## ADDENDUM

NO. 02

**PROJECT NAME:** 2024 Cy Ranch High School Additions And Renovations

**ADDENDUM DATE:** Thursday, November 20, 2024

2 FINISH PLAN - AREA BB - SECOND FLOOR  
1/8" = 1'-0"

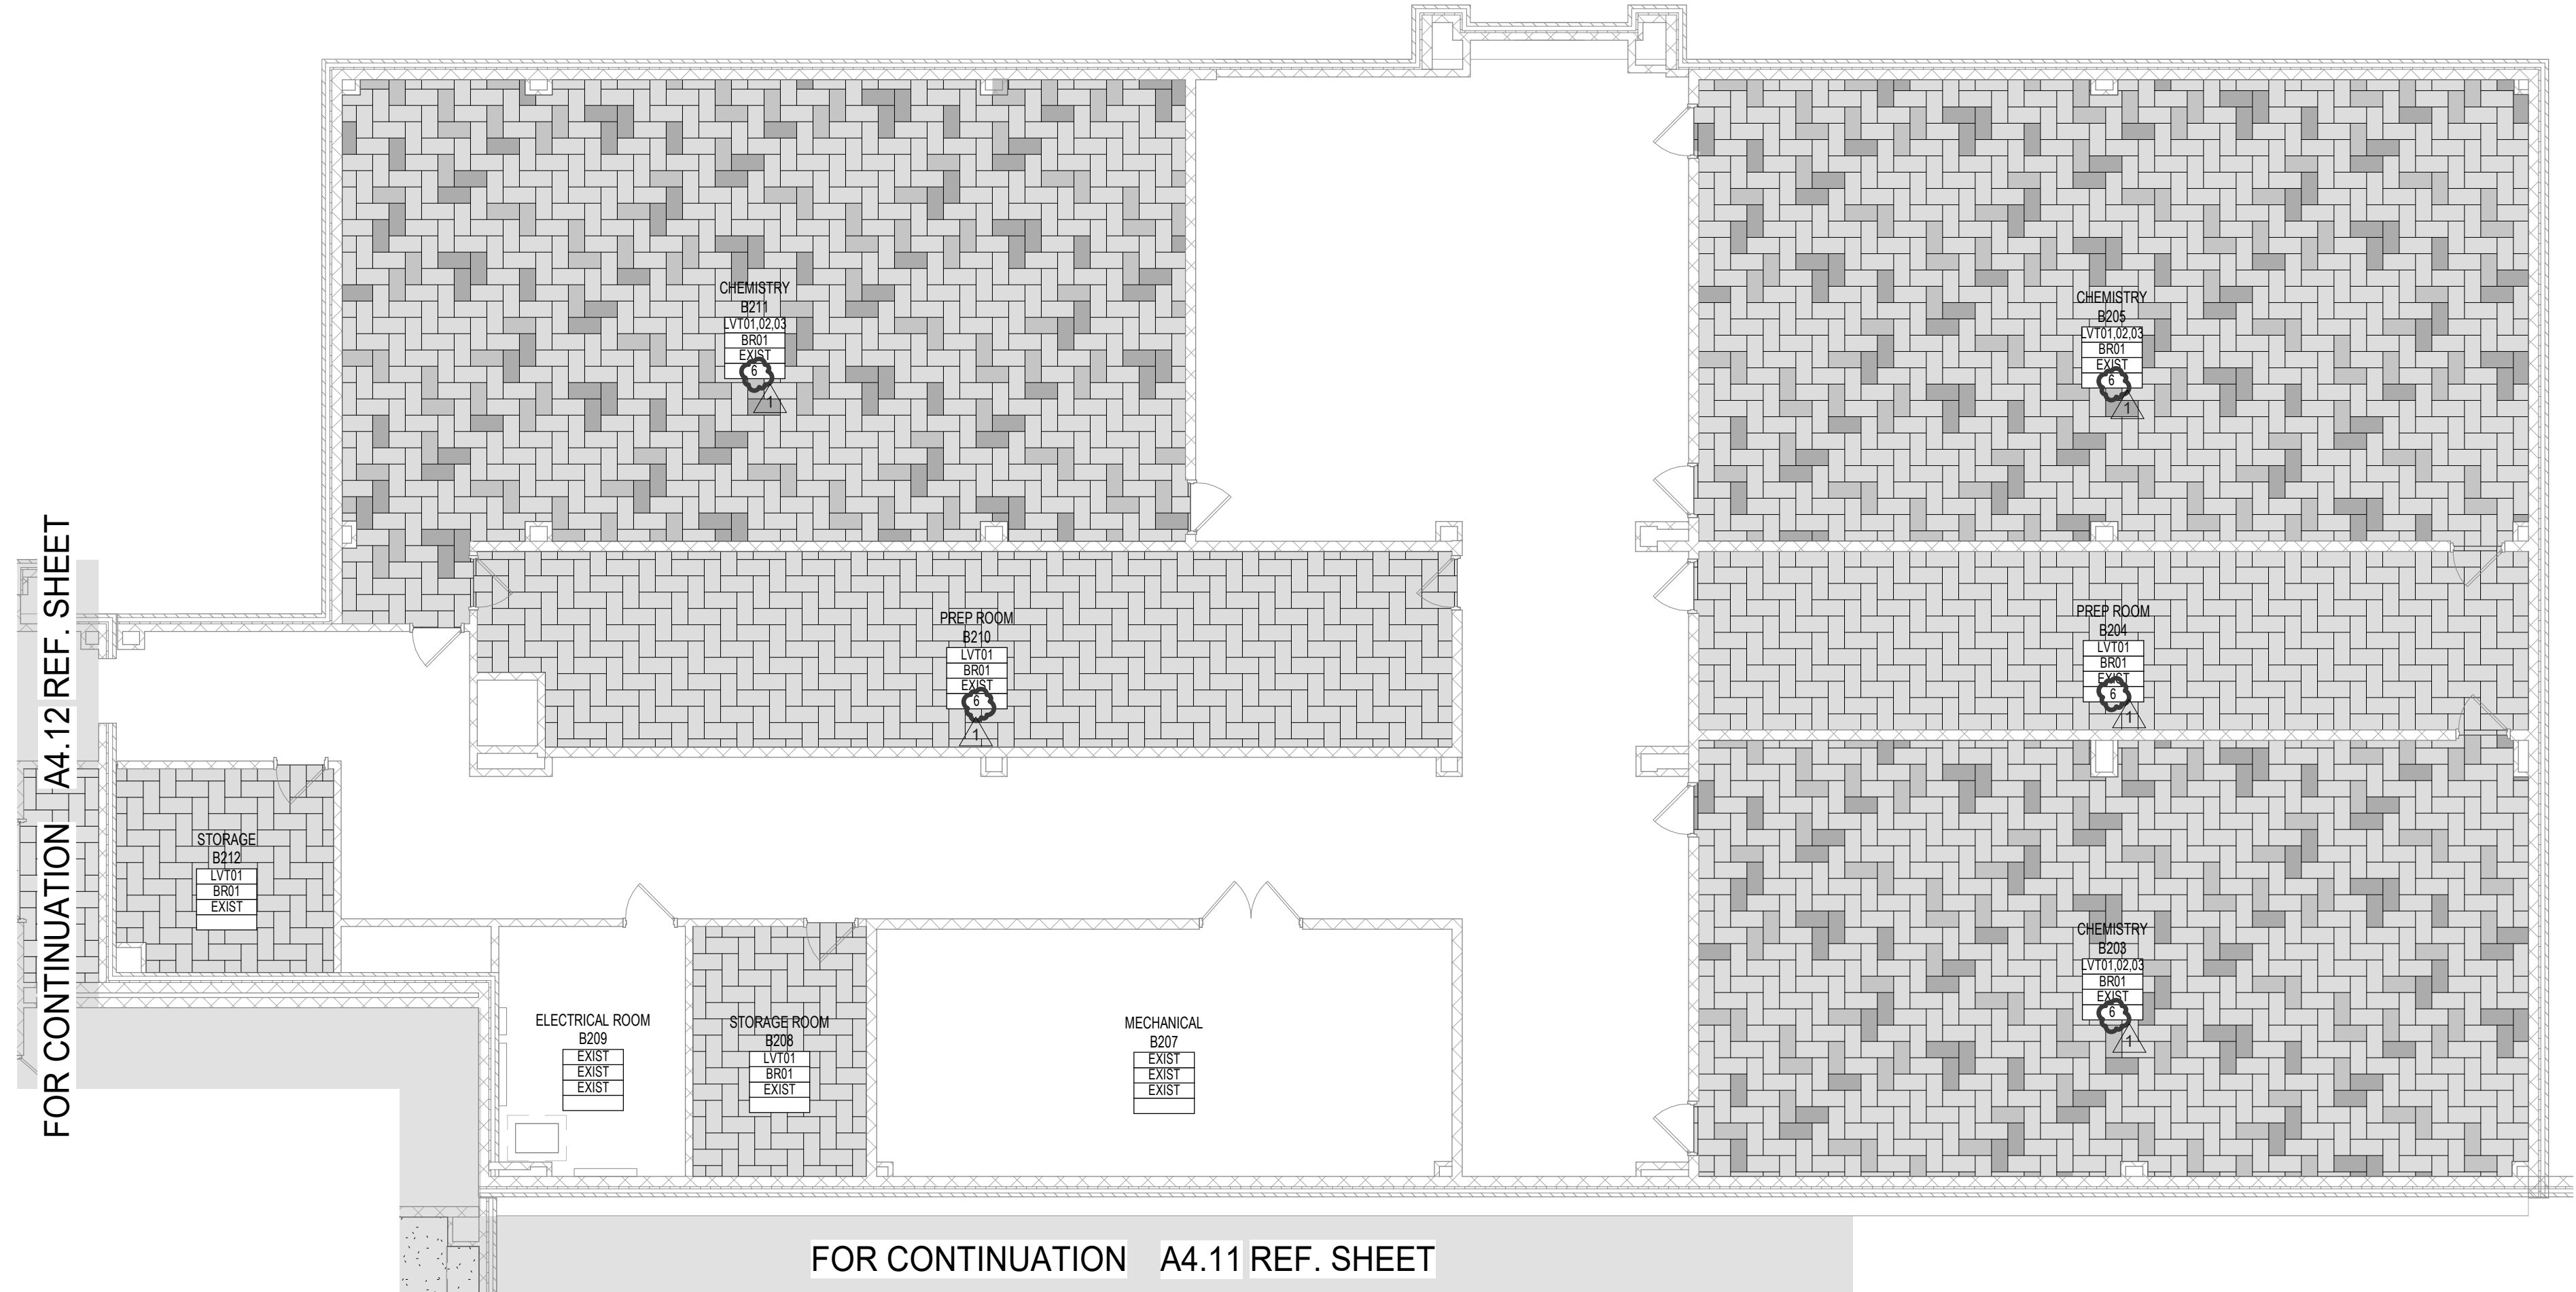
- 1) Detail 2, revise room tag remarks per attached sheet.

**1** FINISH PLAN - AREA H - SECOND FLOOR  
1/8" = 1'-0"

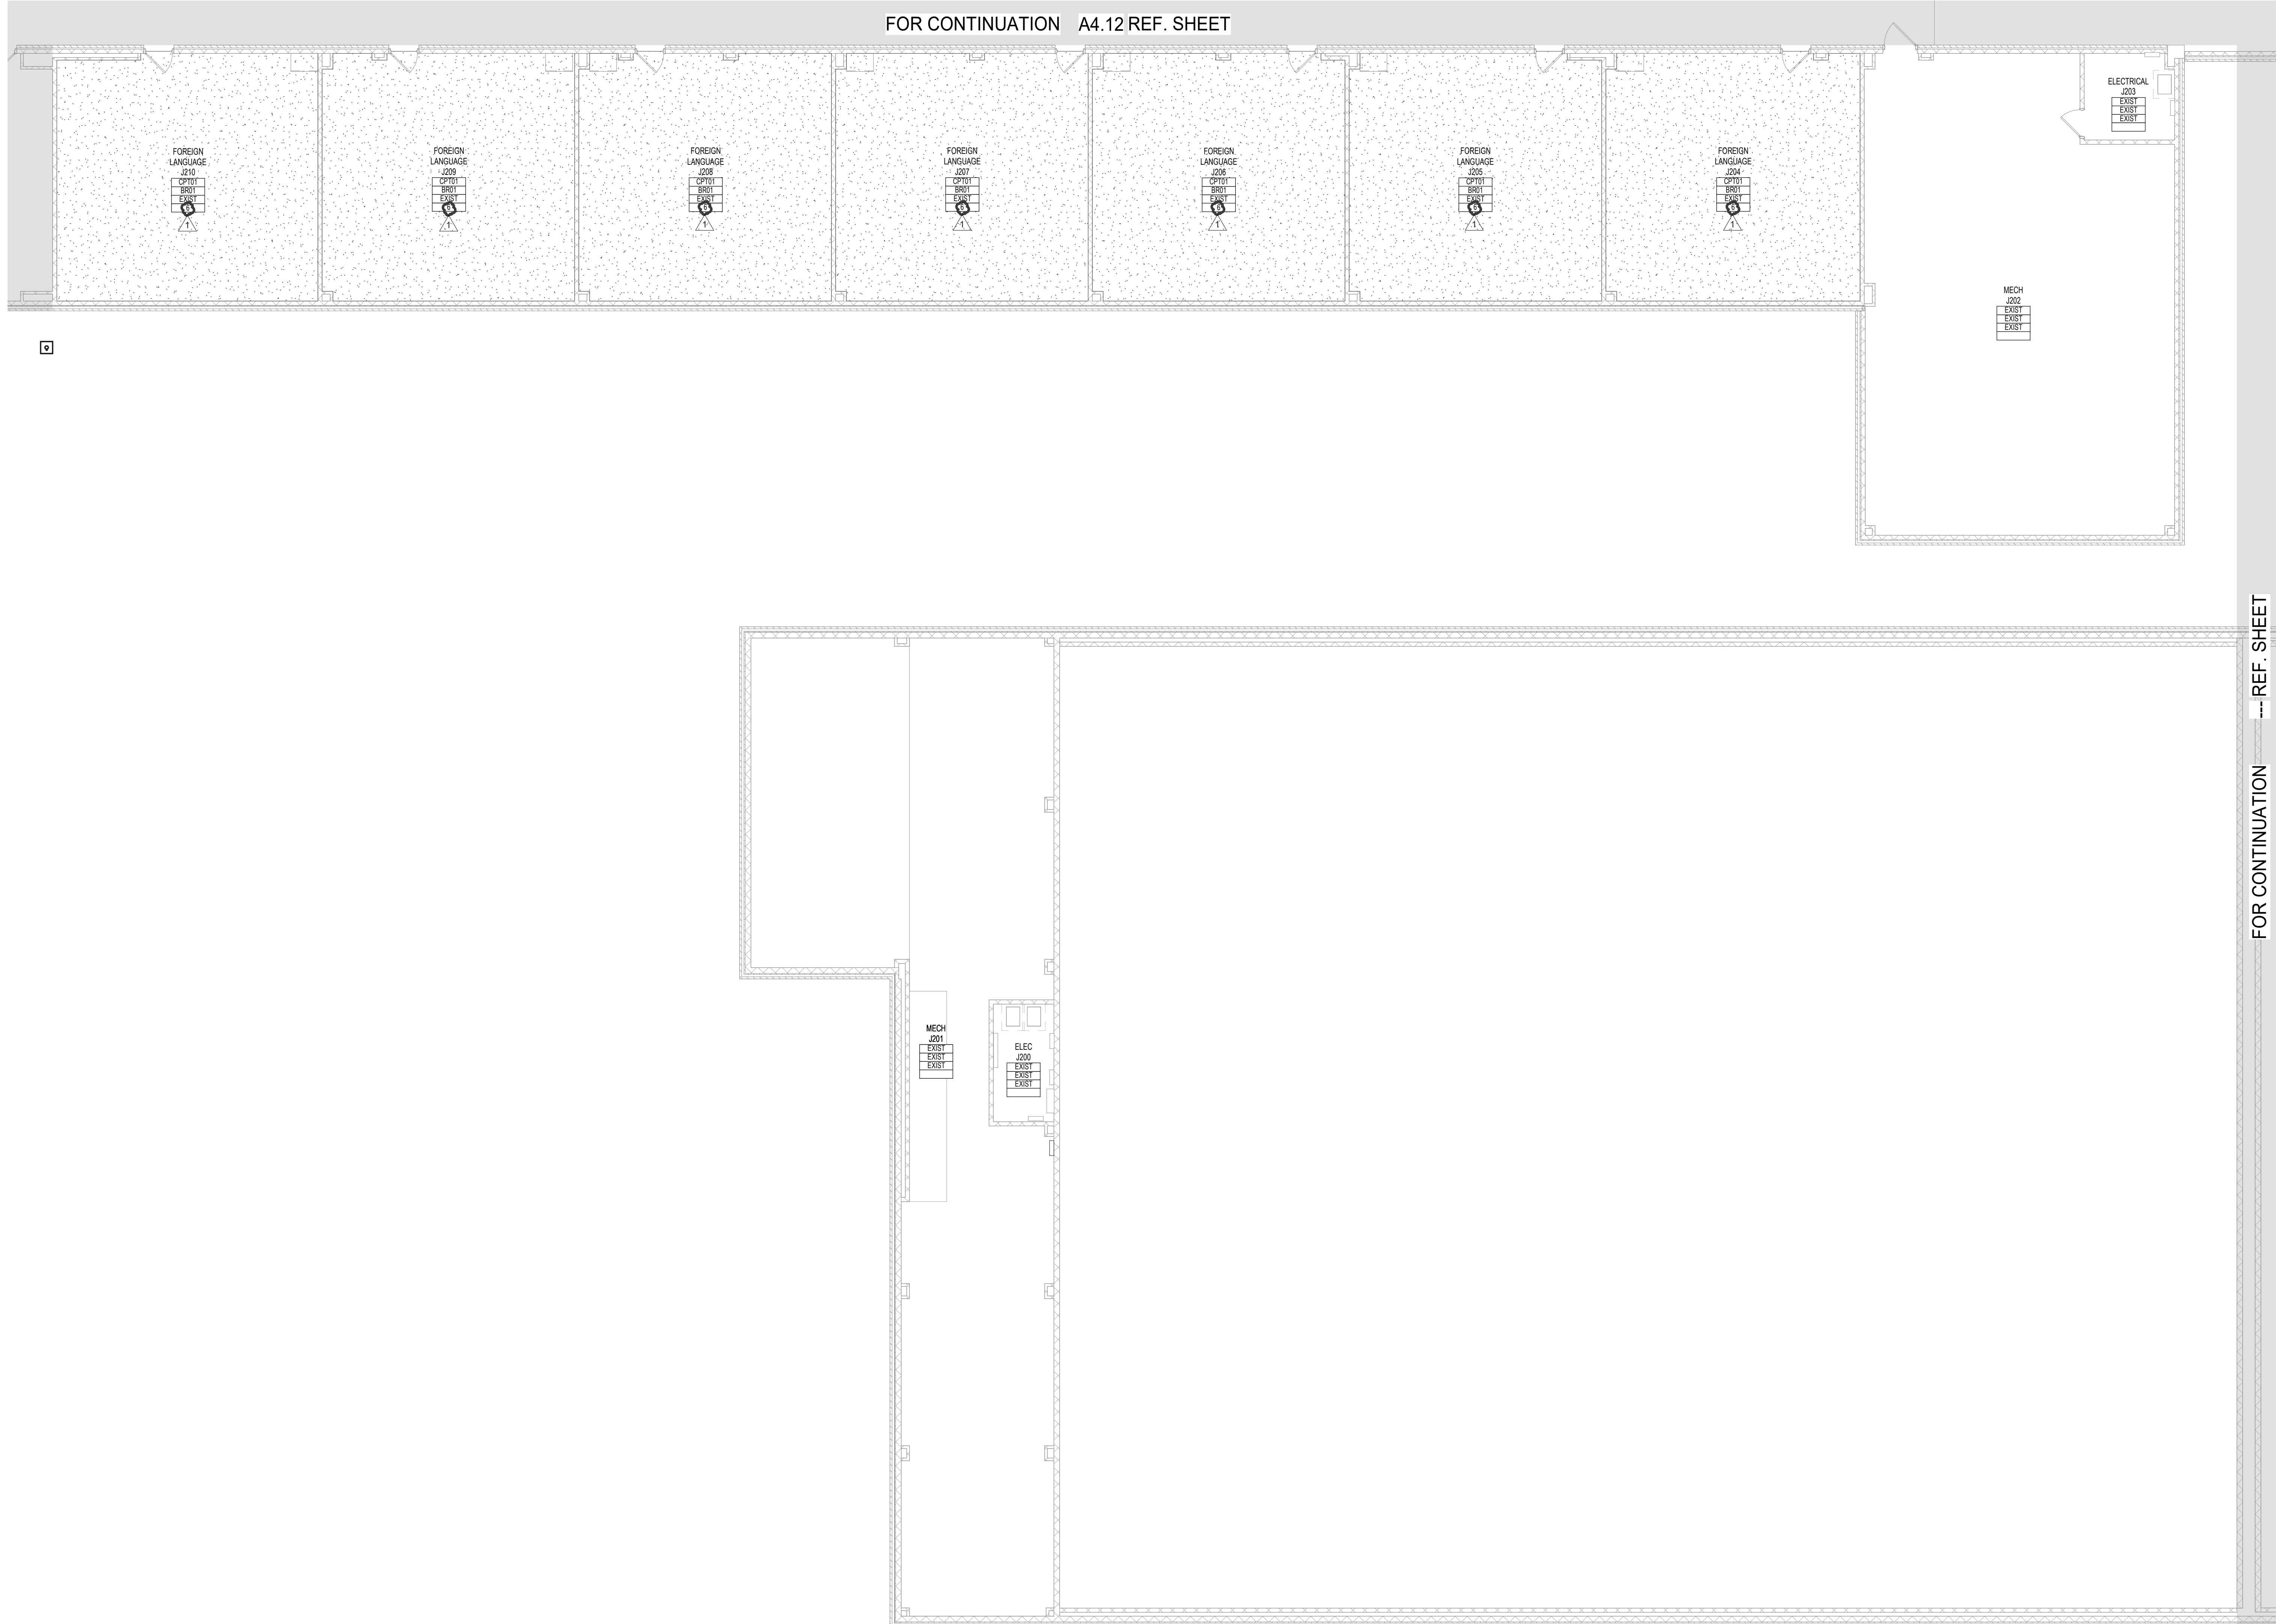
- 1) Detail 1, revise room tag remarks per attached sheet.

**1** A4\_TYP BLACKBOX FLOOR @ BASE  
6" = 1'-0"

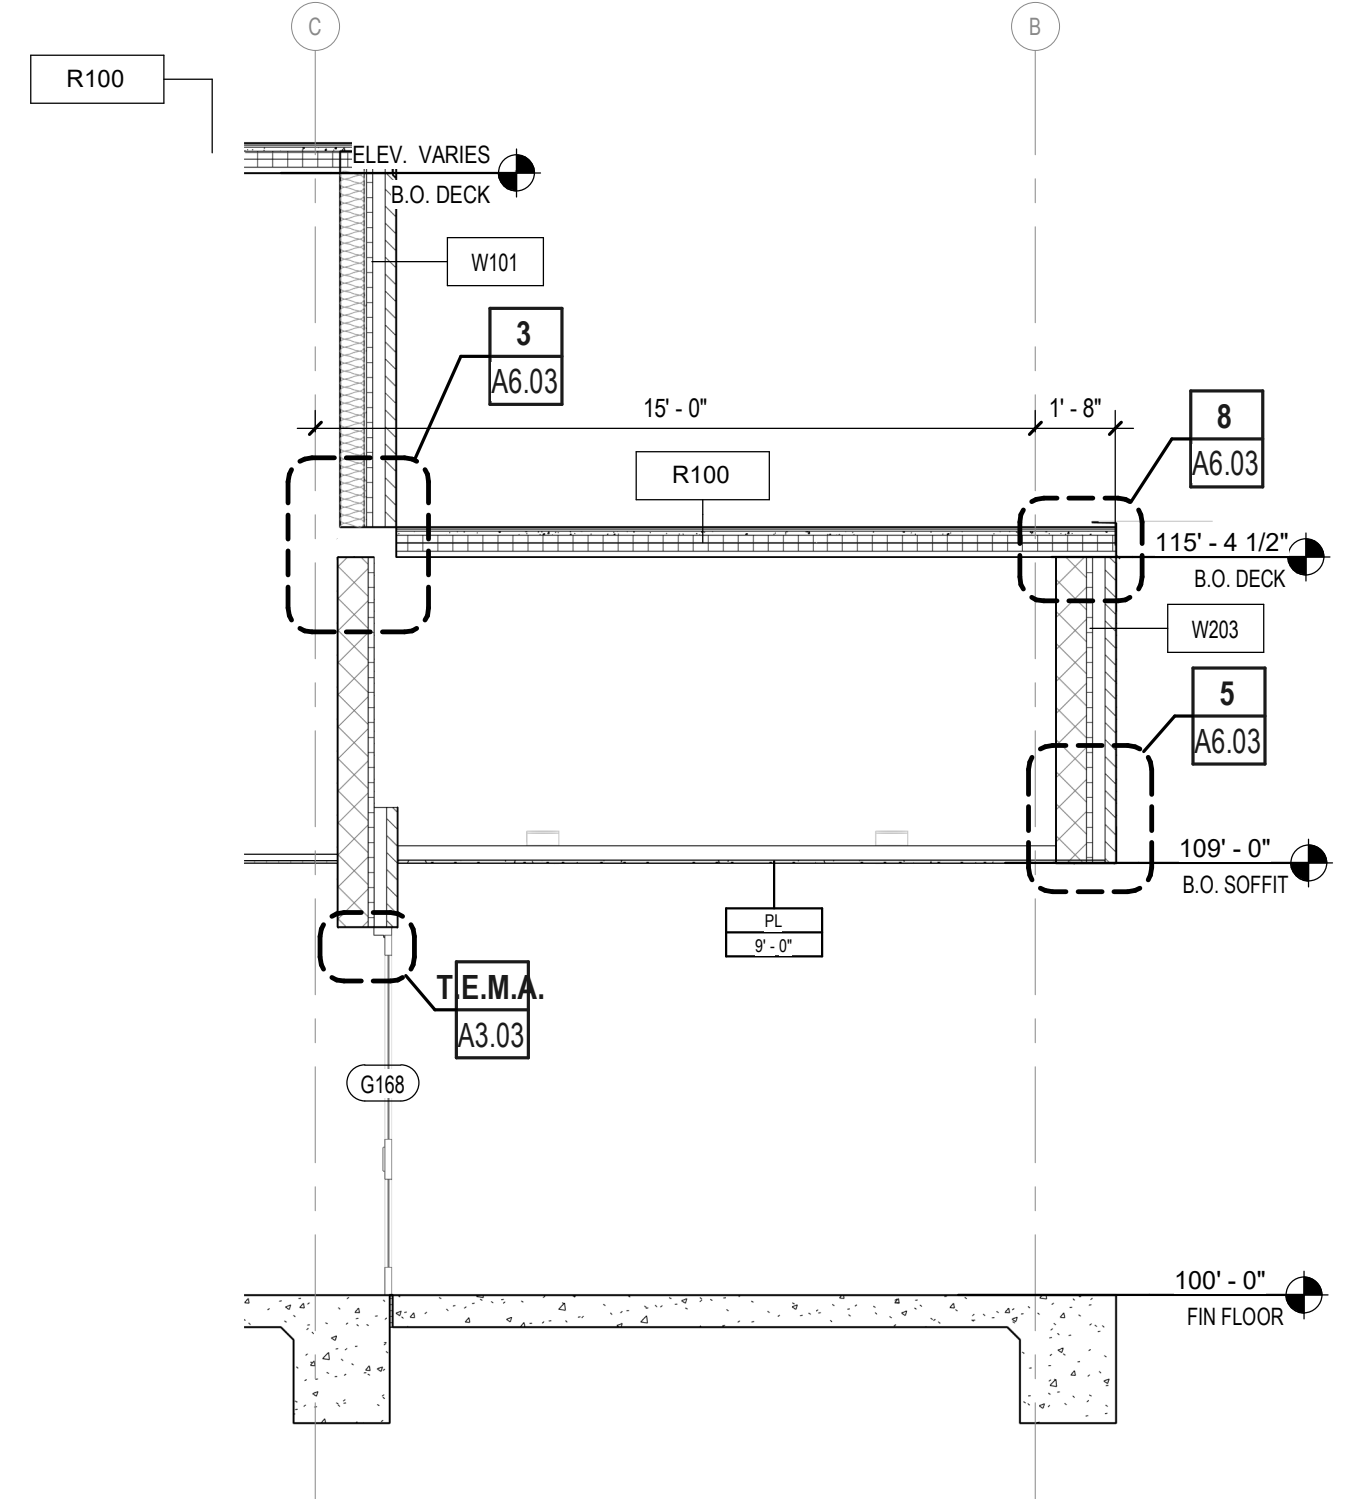
- 1) Detail 1, revise flooring and subfloor per attached sheet.
- 2) Detail 1, revise detail title per attached sheet.
